Re: Protestant TJFA, L.P.'s Exceptions to the Proposal for Decision and the Proposed Order, *Application of Waste Management of Texas, Inc. for a Municipal Solid Waste Permit Amendment; Permit No. MSW-249D*, SOAH Docket No. 582-08-2186, TCEQ Docket No. 2006-0612-MSW.

**SOAH DOCKET NO. 582-08-2186  
TCEQ DOCKET NO. 2006-0612-MSW**

**IN THE MATTER OF THE  
APPLICATION OF WASTE  
MANAGEMENT OF TEXAS, INC.  
FOR A MUNICIPAL SOLID WASTE  
PERMIT AMENDMENT  
PERMIT NO. MSW-249D**

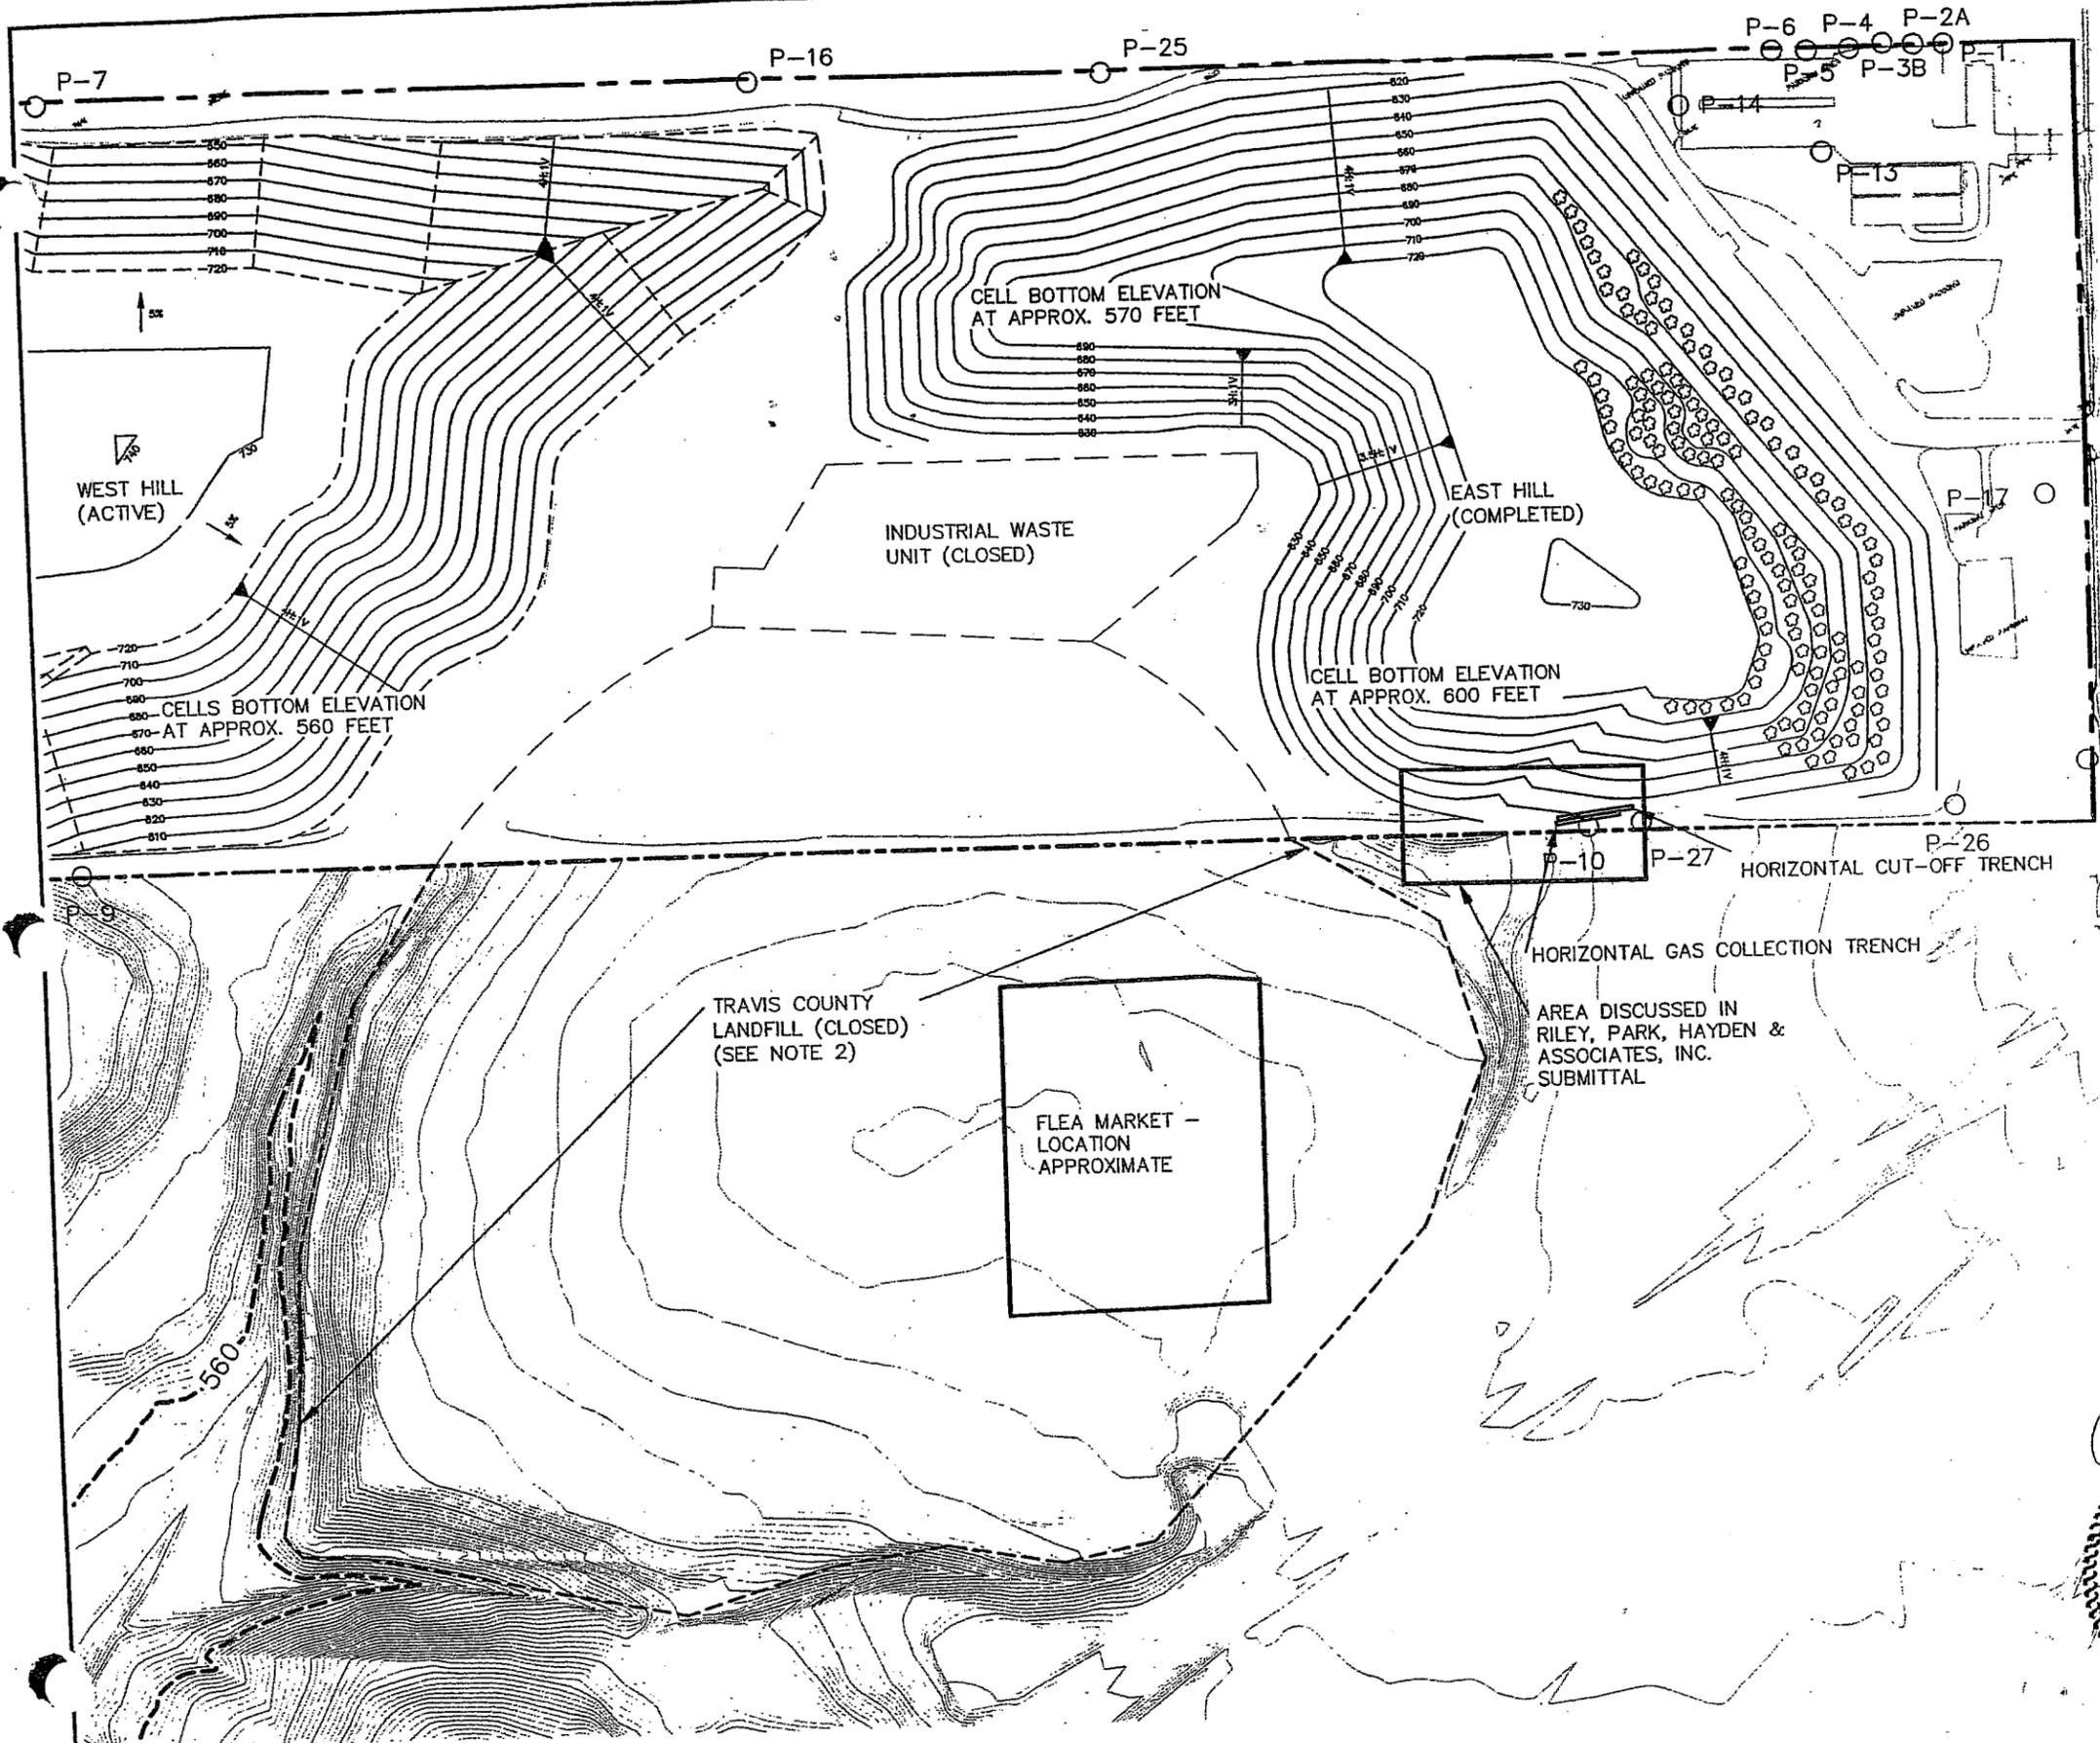
The landfill gas monitoring system proposed in WMTX's application has a gap in perimeter coverage between gas monitoring probes P-9 and P-10. As clearly shown throughout the application—specifically at Figure ATT6-2, the Gas Probe Location Map, and Figure ATT6-5, Gas Probe Spacing Between East and West Hills—approximately half of the entire south side of the perimeter boundary of the ACL facility will not be monitored for gas migration if the application is approved.<sup>11</sup> The “gap” between gas monitoring probes P-9 and P-10 along the southern permit boundary is approximately 3,000 feet—over one-half mile—long.<sup>12</sup> This gap in monitoring coverage, *i.e.*, this lack of landfill gas monitoring, is in direct violation of 30 TEX. ADMIN. CODE § 330.371(a)(2) and (b).

C. *TJFA Exhibit 207*.....204

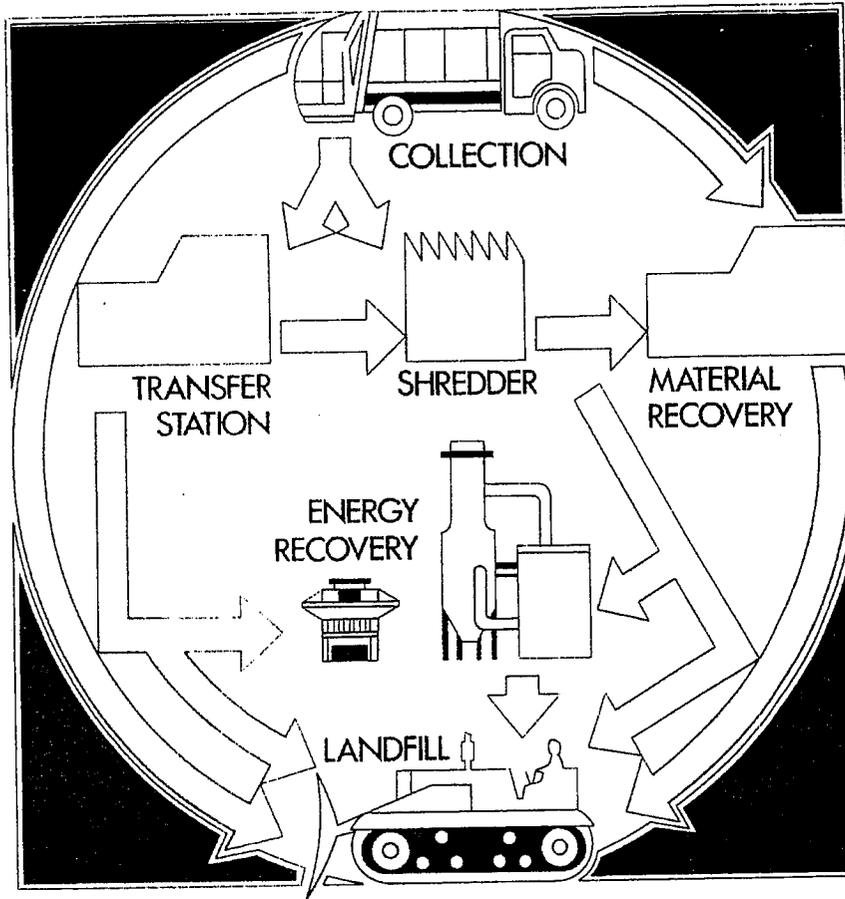
Additionally, while WMTX asserts that there is an “absence of off-site receptors” in the area of the “gap” in landfill gas monitoring coverage, Figure ATT-6-5 contradicts that assertion. Figure ATT6-5 depicts a flea market located approximately 300 feet—less than the length of a football field—south of the ACL permit boundary outside of the “gap” area.<sup>18</sup> The Proposal for Decision does not address these health and safety concerns regarding the “gap” in landfill gas monitoring coverage.

For all of these reasons, the great weight of the evidence in the records supports one conclusion—that the ground water at and adjacent to the ACL facility has been contaminated by the wastes disposed at the ACL facility.

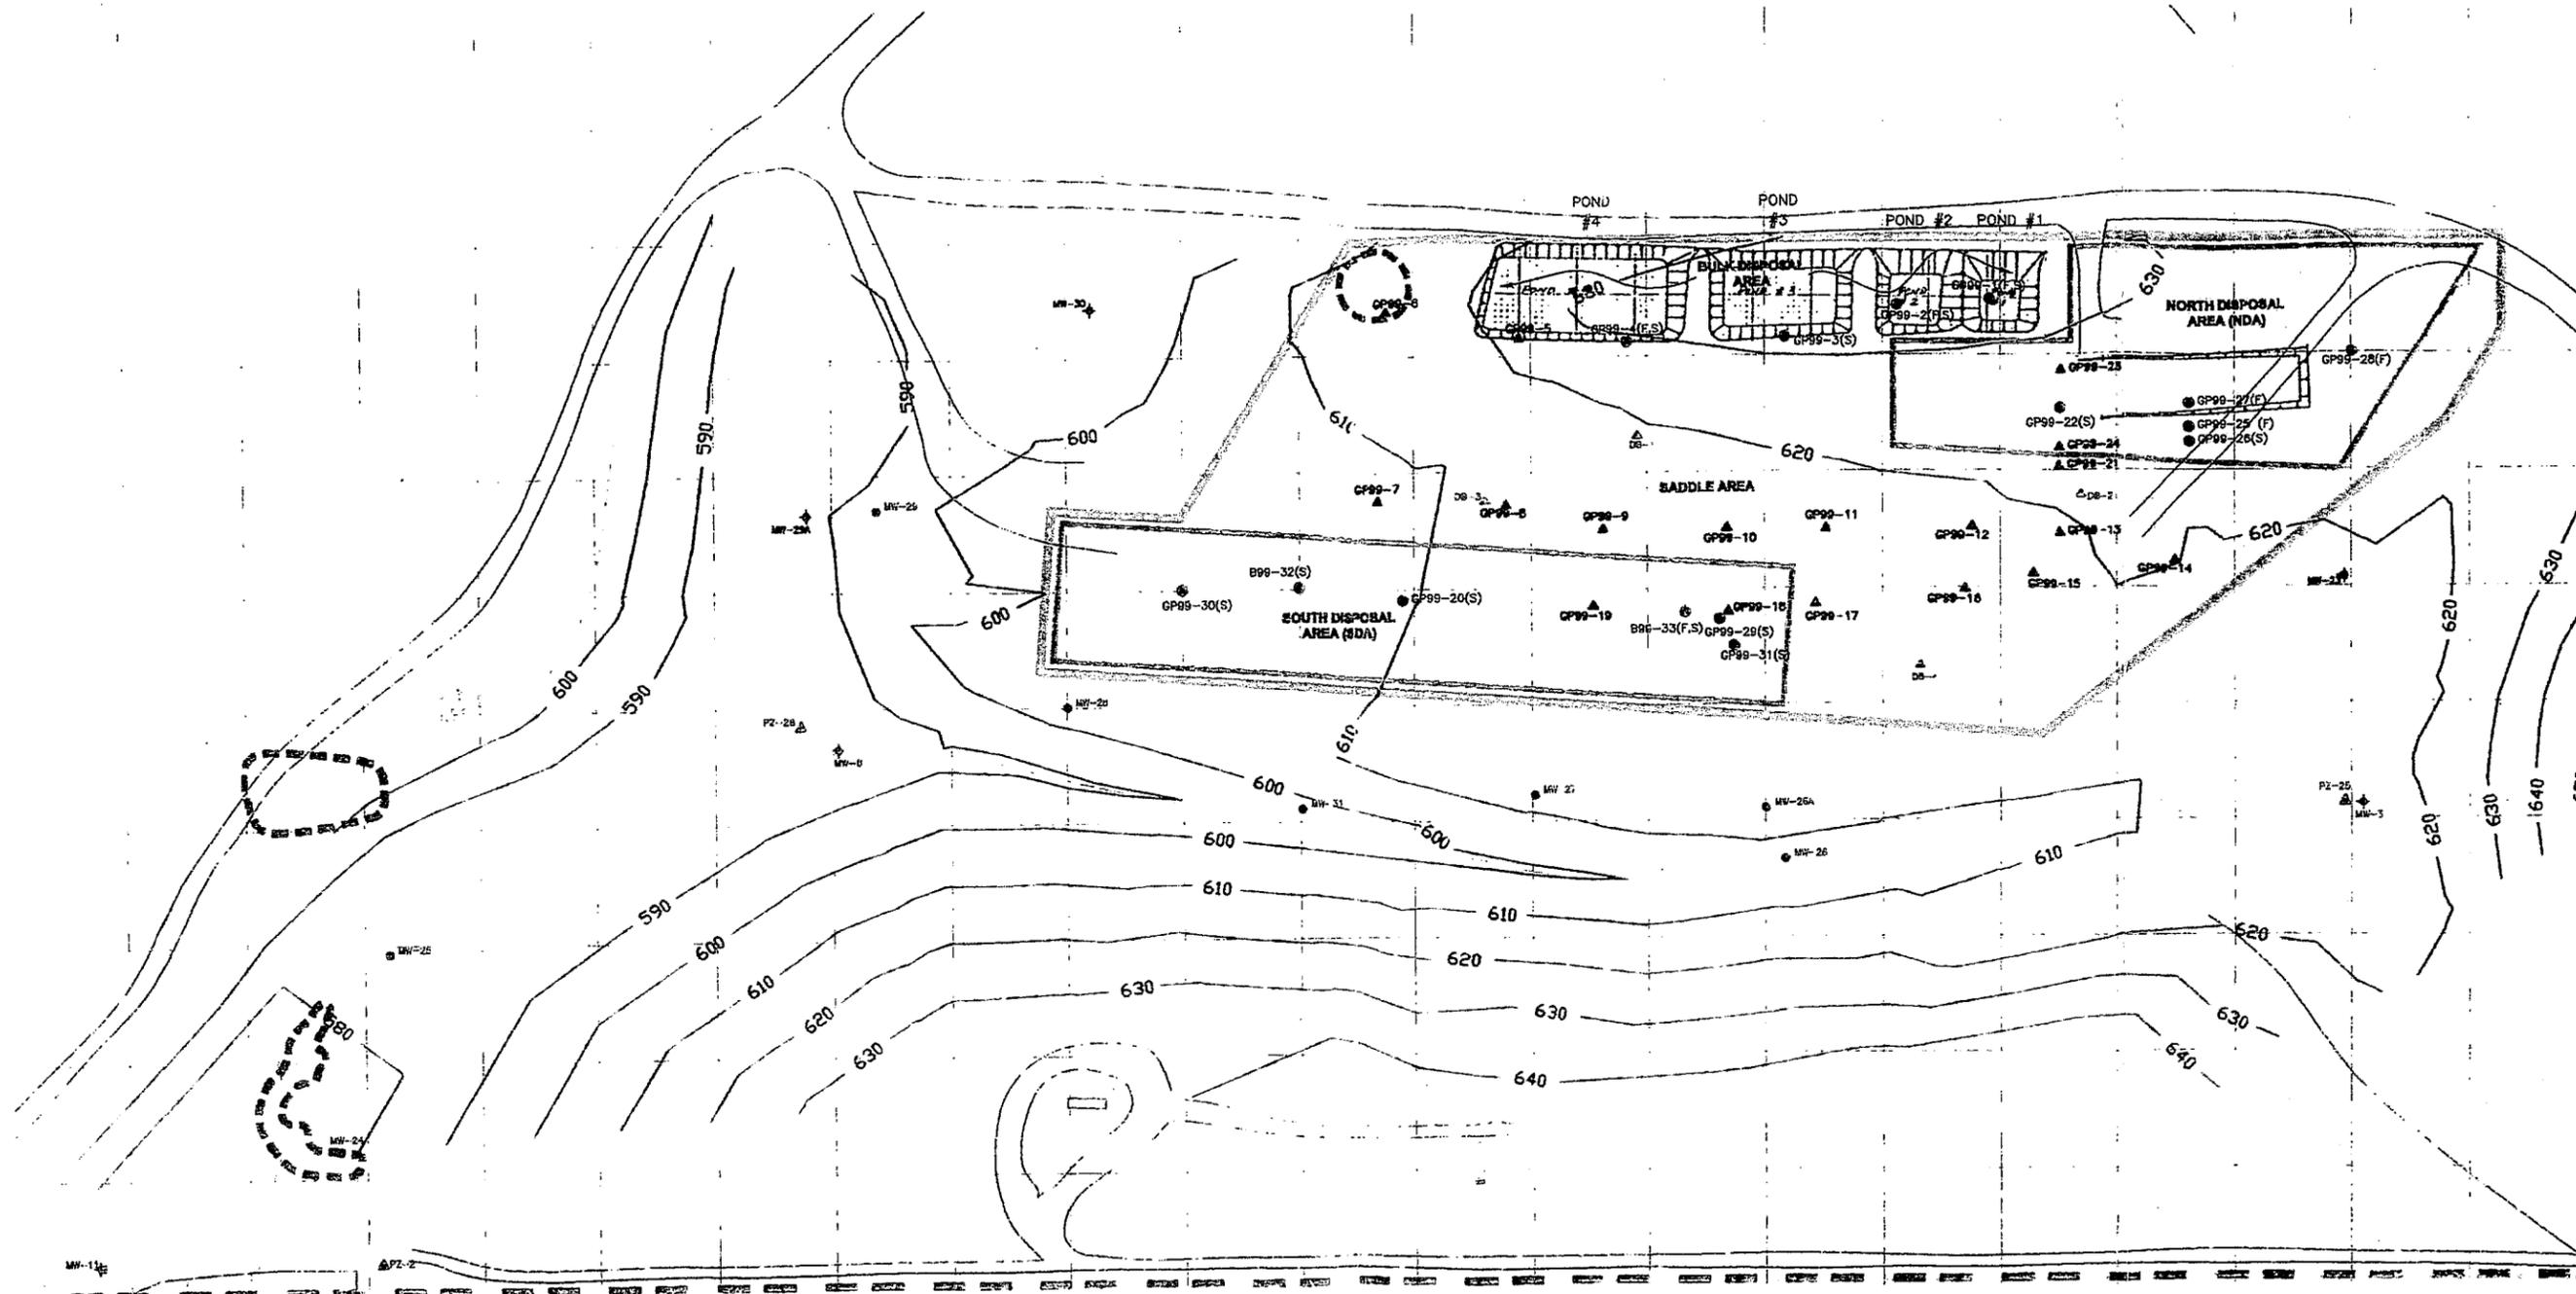
Contrary to the claims in the Proposal for Decision, the ThermoRetec report, portions of which are included in the application, clearly indicates that waste was buried in the drainageway between the Phase I Unit and the IWU. For example, Figure 3-2 in the ThermoRetec report clearly shows that MSW is buried in the drainageway.<sup>81</sup>

<sup>81</sup> See Exh. TJFA 204, ThermoRetec Report, *supra* note 81, at Fig. 3-2 (053). Figure 3-2 of the ThermoRetec report is also included in the application as Figure ATT4-17. See Exh. APP-202, *supra* note 11, at Tech. Complete 1481 (Vol. III, Pt. III, Att. 4 at Fig. ATT4-17), attached hereto and incorporated herein for all purposes as Attachment 5.

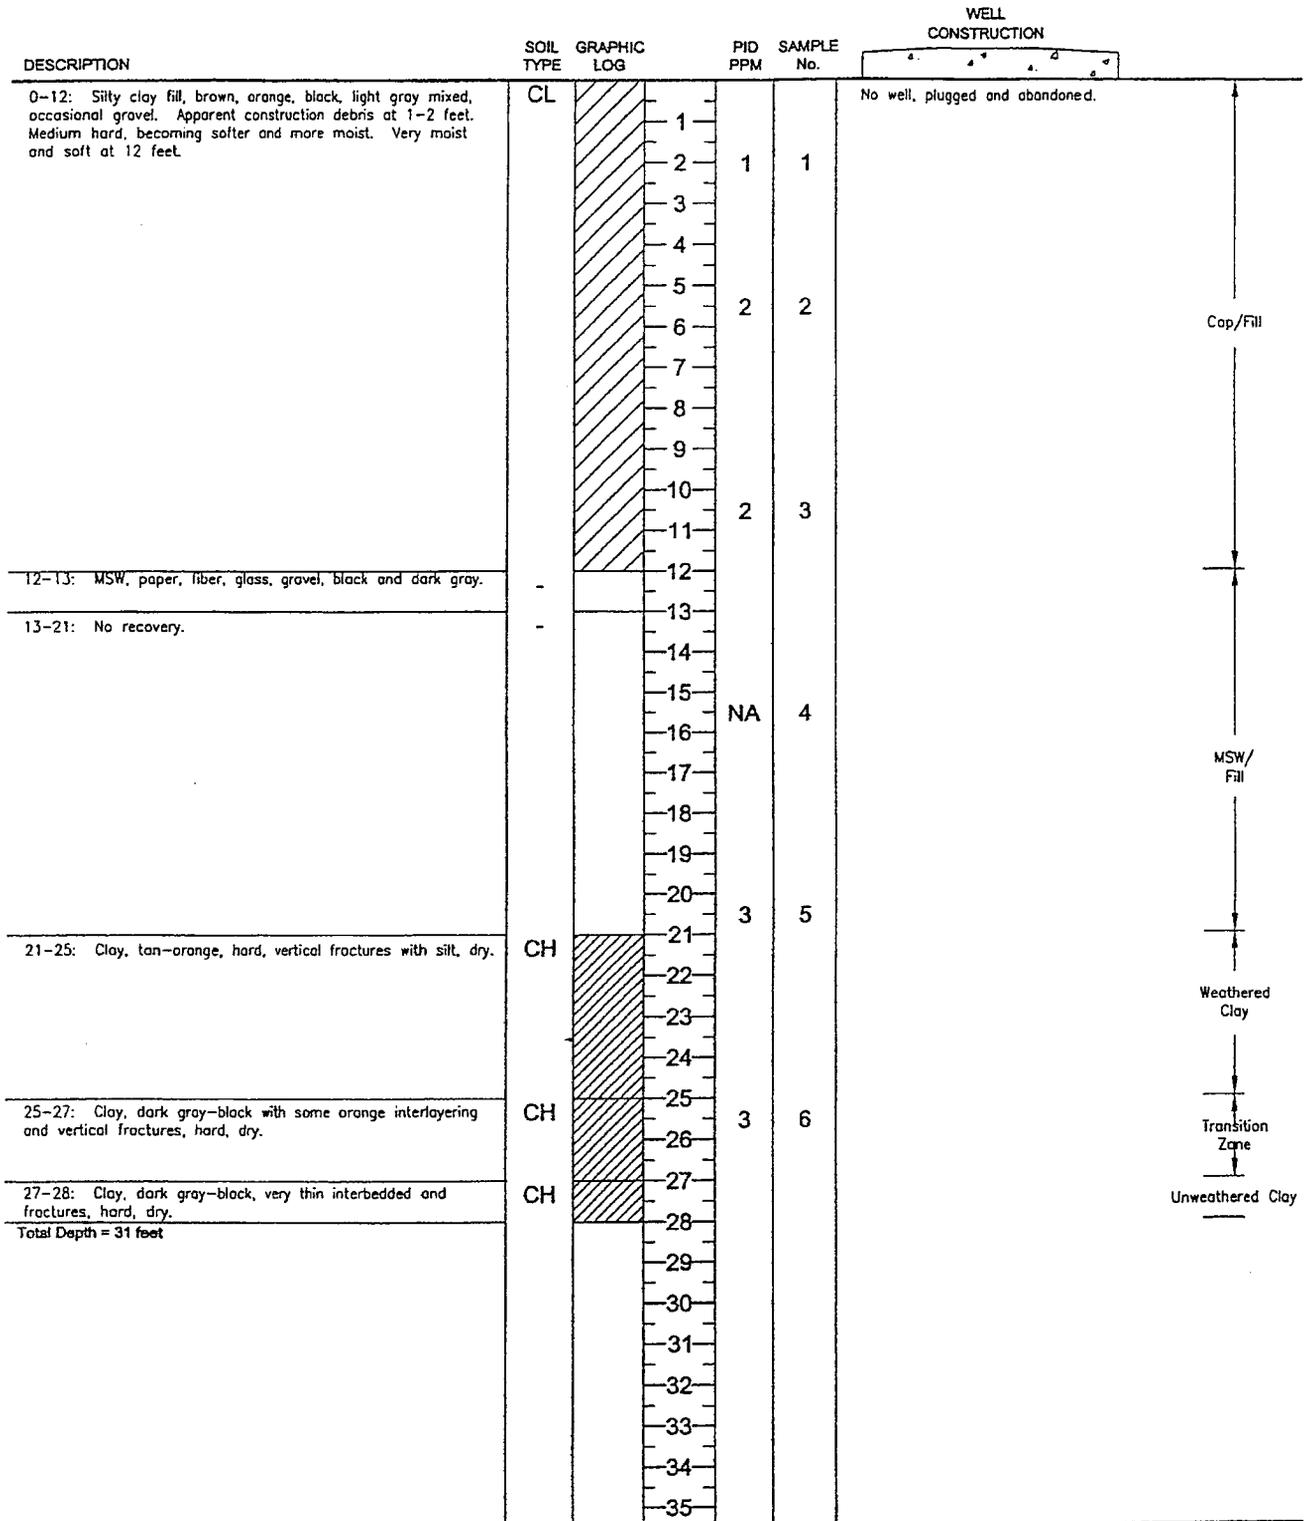
<sup>83</sup> See *id.* at Tech. Complete 2433 (Vol. IV, Pt. III, Att. 4, appx. E at Boring Log Hole No. MW-99-24); *id.* at Tech. Complete 2438 (Vol. IV, Pt. III, Att. 4, appx. E at Boring Log Hole No. MW-99-25); *id.* at Tech. Complete 2439 (Vol. IV, Pt. III, Att. 4, appx. E at Boring Log Hole No. MW-99-26); *id.* at Tech. Complete 2446 (Vol. IV, Pt. III, Att. 4, appx. E at Boring Log Hole No. MW-99-31). All of these boring logs are attached hereto and incorporated herein for all purposes as Attachment 7. Although not depicted on Figure 2-1, a subsequently drilled boring, MW-32, which was drilled by MFG Consulting Scientists and Engineers in 2002, is in the creek bed north of Boring Log Hole No. MW-99-25. The boring log for MW-32 identifies MSW buried ten to twelve feet below the creek. See *id.* at Tech. Complete 1677 (Vol. III, Pt. III,
